**Response to  
Request for Additional Information No. 30 Supplement 2, Revision 0**

**U. S. EPR Standard Design Certification**

**SRP Section: 15.06.05 - Loss of Coolant Accidents Resulting From Spectrum of  
Postulated Piping Breaks Within the Reactor Coolant Pressure Boundary**

**Question 15.06.05-20:**

**Figure 15.06.05-20-1—U.S. EPR SBLOCA Break Spectrum Comparison Figure – Peak Cladding Temperature**

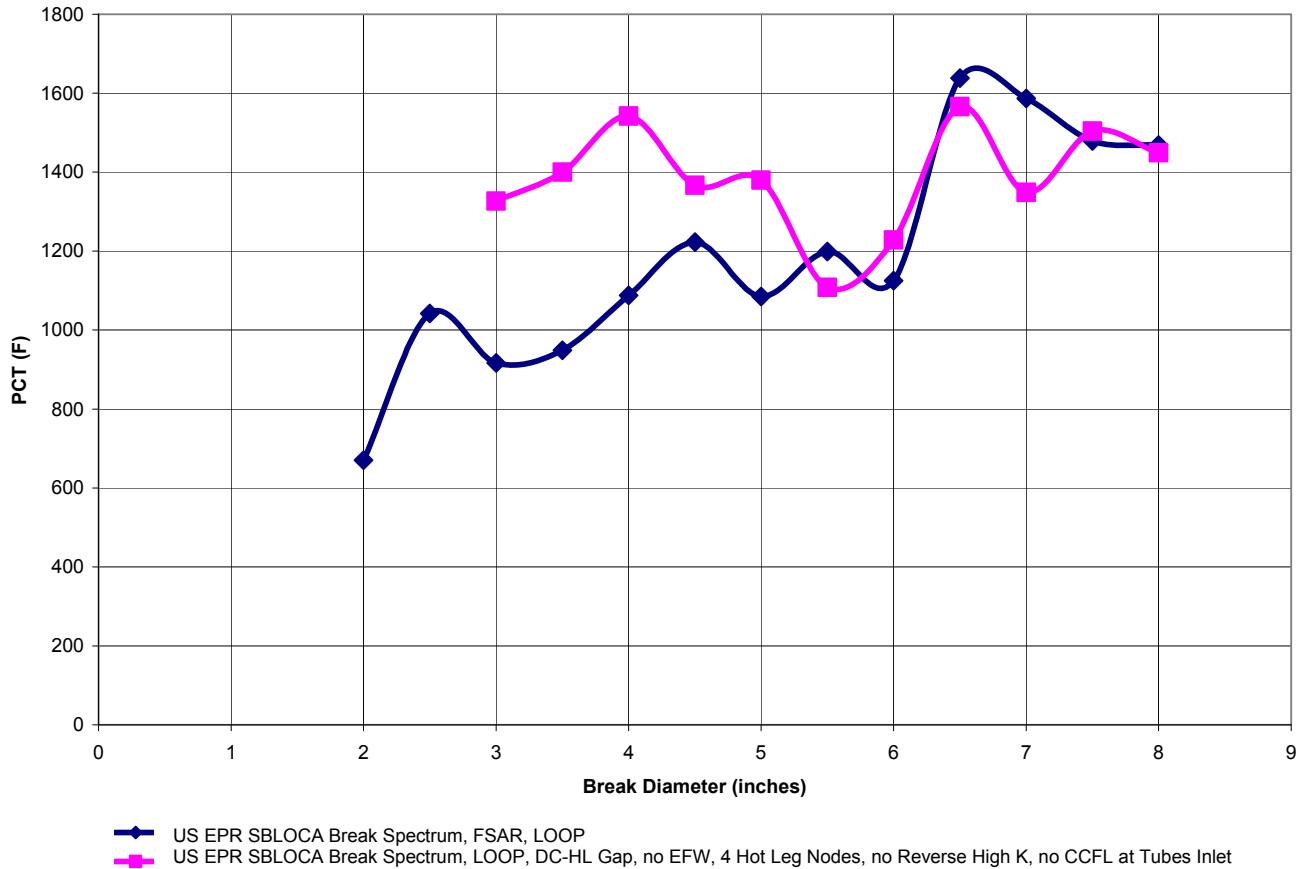
The limiting size for the SBLOCA has changed from 4" in ANP-10263 to 6.5" in the FSAR. Please explain what model assumptions resulted in this change of the limiting break size.

The higher peak cladding temperature (PCT) results for the five break spectra are summarized in Table 15.06.05-20-1, and in Figure 15.06.05-20-1. The results indicate that, regardless of the modifications, the limiting breaks consistently occur in the 6-7 inch range. The fifth break spectrum (BS5) results, which resembles most closely the sample problem (although the nodalization is not identical), show a 24°F lower PCT for the 4 inch break compared to the 6.5 inch break. However, this difference is considered insignificant (see Figures 15.06.05-20-3 and 15.06.05-20-5).

**Figure 15.06.05-24-7—Peak Cladding Temperature Comparison – 6.5 in. Break**

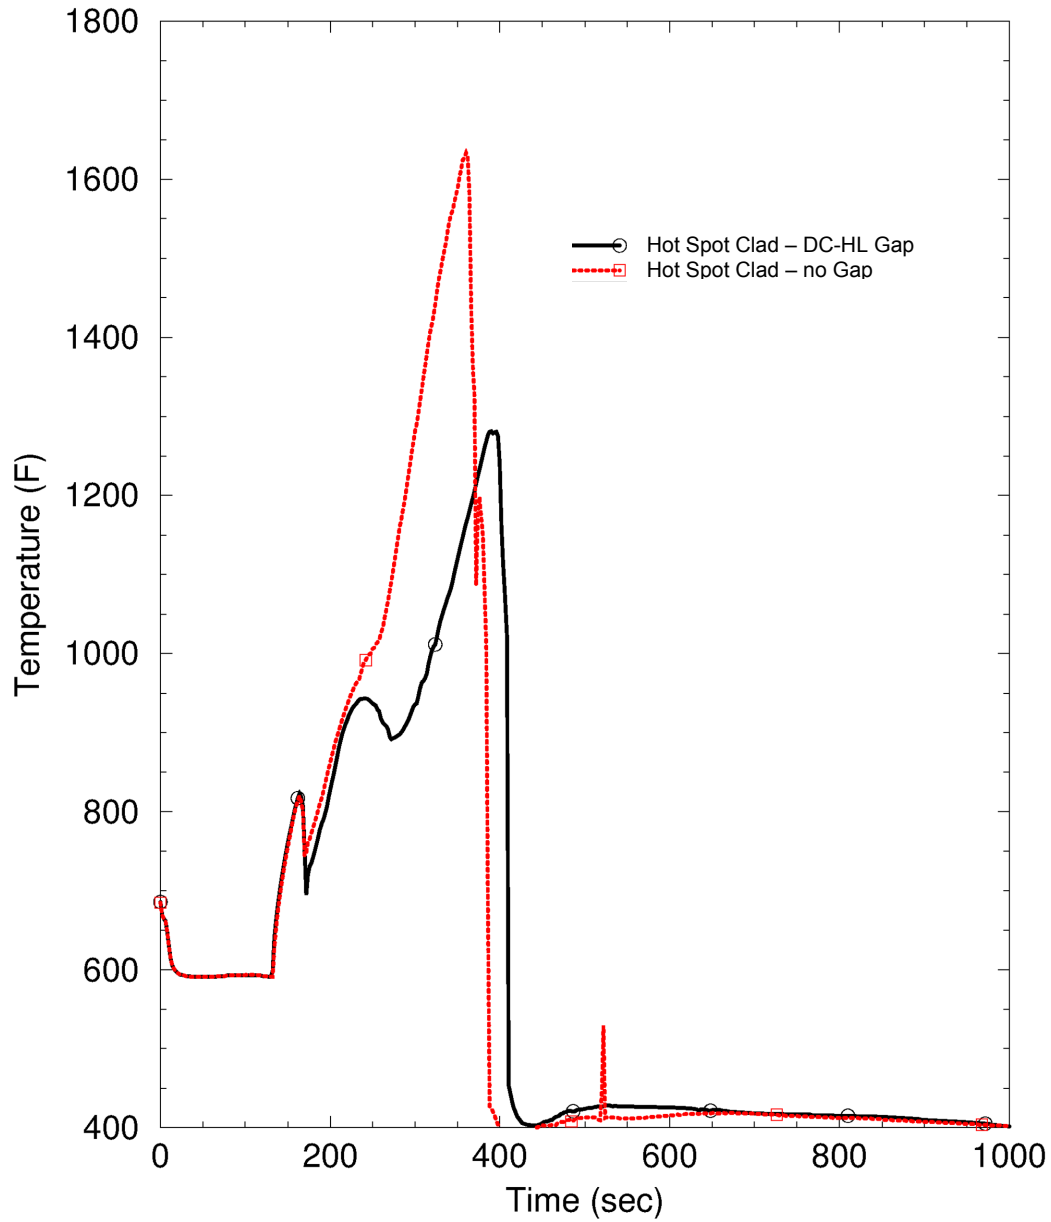
The SBLOCA calculations assume no leakage paths between the hot legs and the vessel downcomer. Please justify this assumption and discuss its impact on the analysis and related safety conclusions.

As shown in Tables 15.06.05-24-2, 15.06.05-20-2, and 15.06.05-20-3, the SBLOCA with the DC-HL bypass open results in a higher PCT and greater amount of metal-water reaction in the break range 3 to 5.5 inches than in the FSAR analysis. For the 4 inch break, the PCT and the amount of metal-water reaction results are comparable. The reason that smaller breaks have higher PCT with the DC-HL gap open can be seen in the case of the 5 inch break. The 5 inch break case with the gap open is more limiting for the PCT due to the loop seal clearing time. For the FSAR analyses, all four loops cleared before 400 seconds. When the gap is present, two loop seals clear at 360 seconds, while Loop 1 and Loop 4 clear later at 670 seconds due to the DC-HL bypass path for venting (see Figure 15.06.05-24-1 and -2). The first PCT peak is more limiting when the DC-HL gap is not present because there is more core level depression when there is no venting and the loops are plugged (see Figure 15.06.05-24-3). The PCT is higher because the loops clear later than in the FSAR analyses (see Figure 15.06.05-24-4). For the larger breaks (6.5 inch and 7.0 inch, which are limiting for U.S. EPR) there is only one heatup period, and there is greater core uncover when the DC-HL gap is closed, as shown in Figure 15.06.05-24-5 and Figure 15.06.05-24-6. After the loop seals clear, recovery is to a lower level, and subsequently higher PCT, as shown in Figure 15.06.05-24-7 and Figure 15.06.05-24-8.
